Product Change Notice (PCN)

PCN Number: PCN-0380142-01

CDS-25148

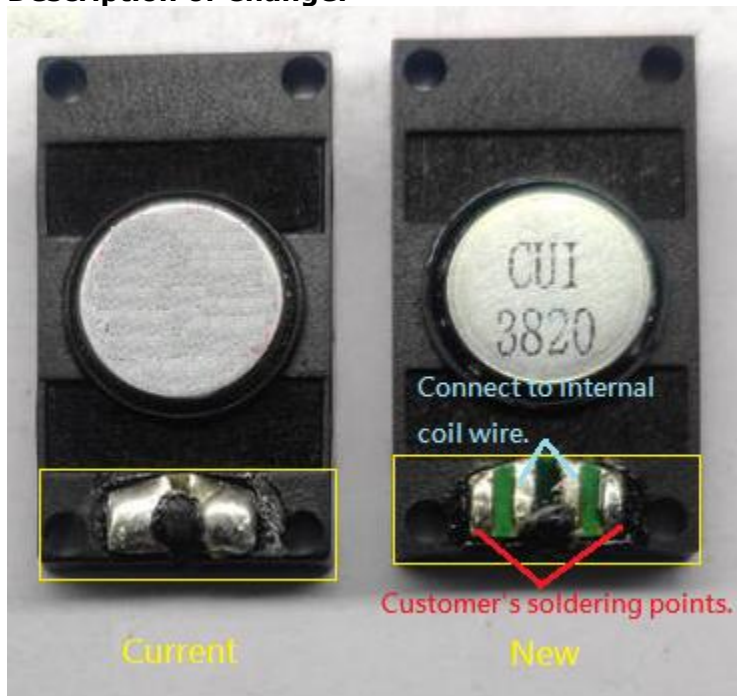
To insulate the heat from the inside coil wire, and to reduce the coil wire breaking when wire is soldered
